**DELAWARE HOSPITAL FOR THE CHRONICALLY ILL
CANDEE BUILDING 200 WING
NURSES STATION RENVOATION
100 SUNNYSIDE ROAD, SMYRNA, DELAWARE 19977
DBF #586B037.I01 ❖ OMB/DFM #MC351400046**

JULY 8, 2019

ADDENDUM NO. 2

TEMPORARY INFILL DETAIL

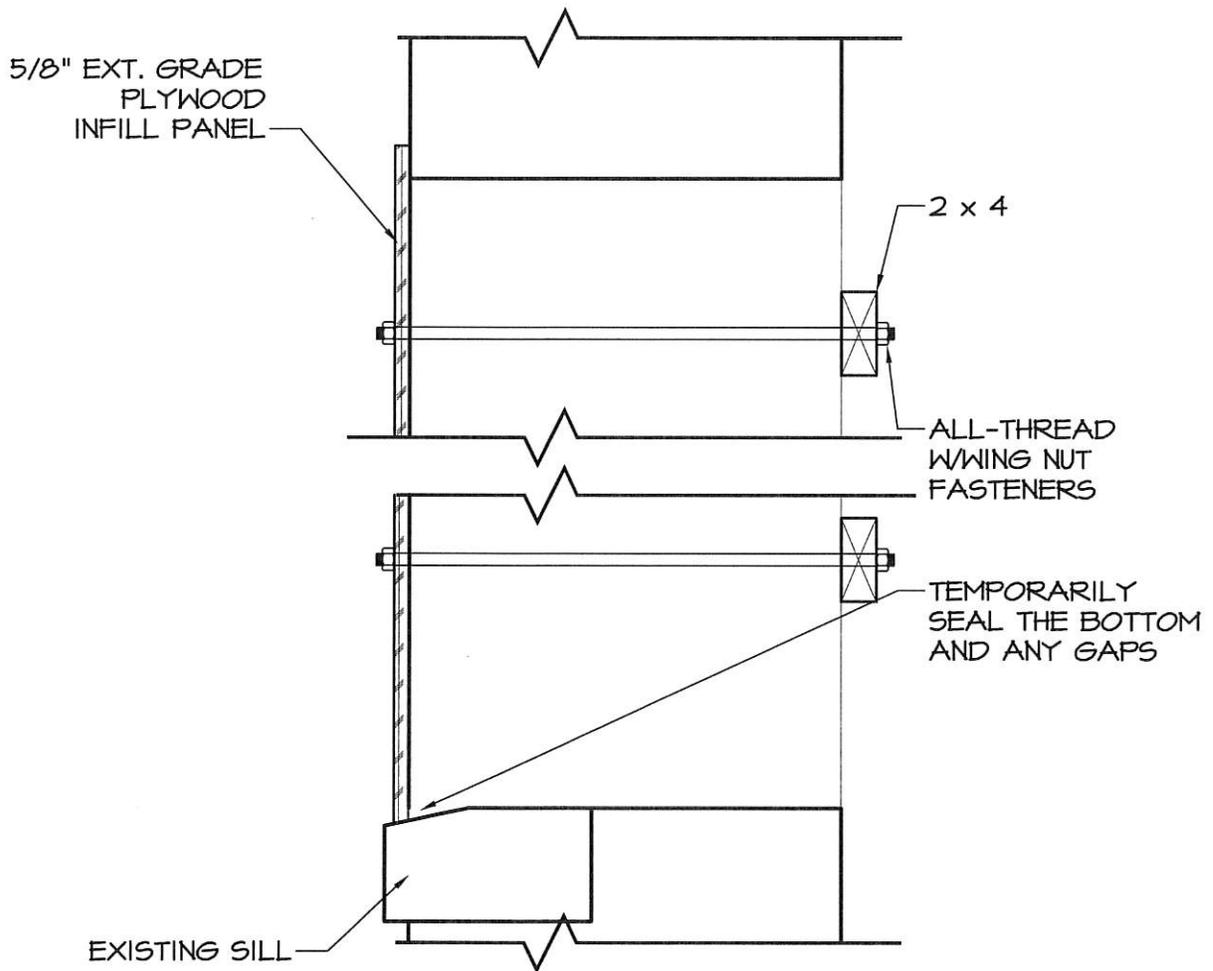
- Item No. 5 The glass block construction shall be silicone joints and the pattern shall be clear.
- Item No. 6 Clarification: The abatement contractor will remove the existing window and install the plywood, blocking and rods – see attached detail. The GC will be responsible to provide and install foam seal gasketing around perimeter to prevent air, water and insects from penetrating the space.

NOTE: GC SHALL VERIFY OPENING SIZE PRIOR TO CUTTING PLYWOOD AND WALL THICKNESS FOR THE ALL-THREAD BOLTS.
